Response to: APACHE 33B-20, API #: 043-06157, Insp. #:695106759 (on photos)
Insp Doc #:695106760

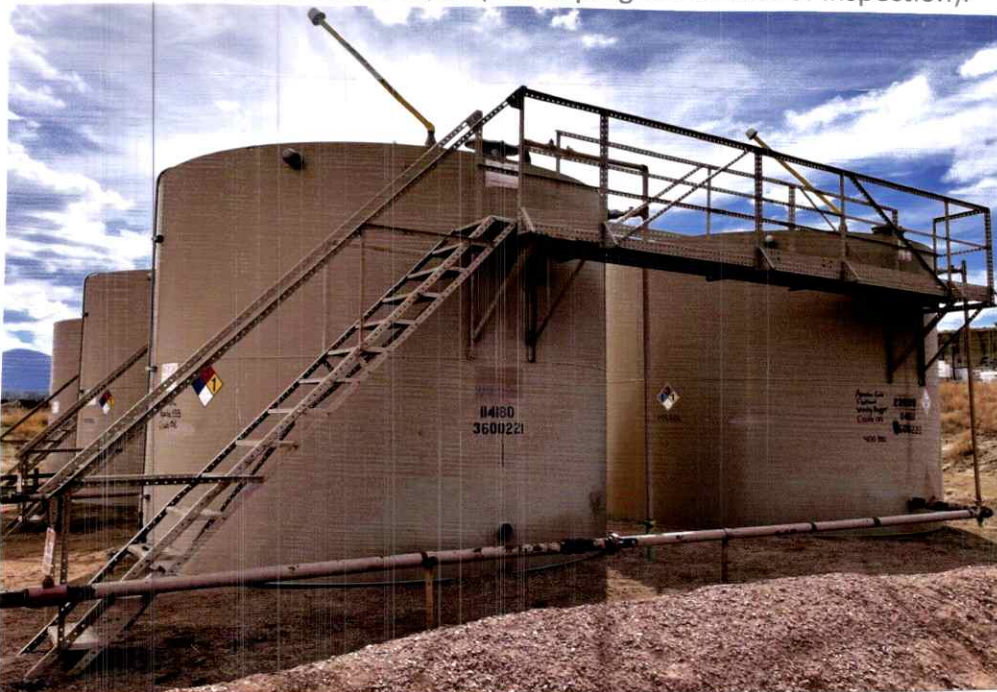
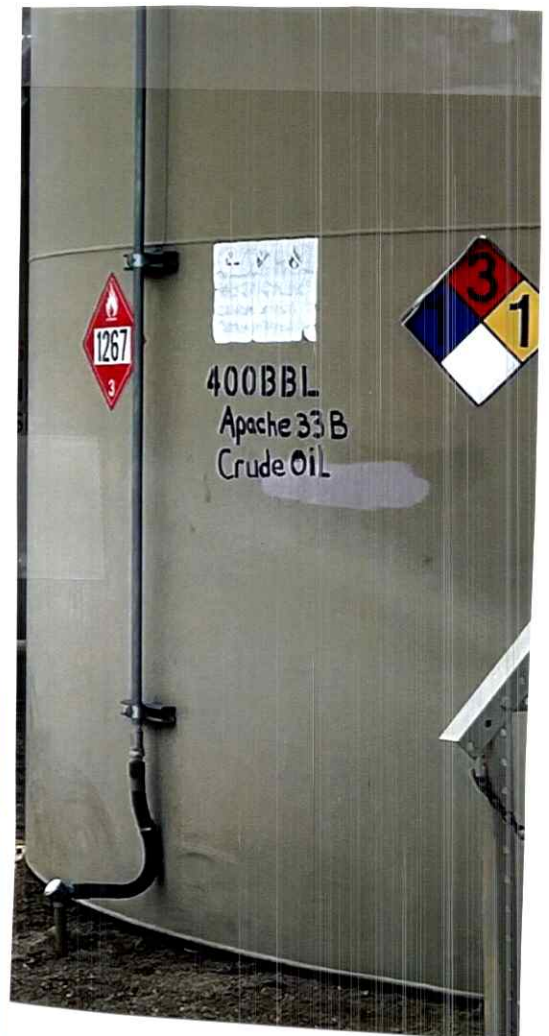
REMOVE VEGETATION FROM INSIDE TANK BATTERY
CONTAINMENT PER RULE 606. CA DATE 10-3-2022

Install battery sign to comply with Rule 605.e (separate battery sign is required for wells servicing battery).
THIS IS SECOND NOTICE OF THIS CORRECTIVE ACTION. IMMEDIATE ACTION IS REQUIRED.

Placards for Crude and NFPA, but contents not spelled out.

-Operator completed task 9/21/22 (was in progress at time of Inspection).

-Operator installed tank battery sign the following day, 9/28/22.

-Operator labeled tanks with respective well names, and confirmed content, volume and correct labeling on 9/28/22.
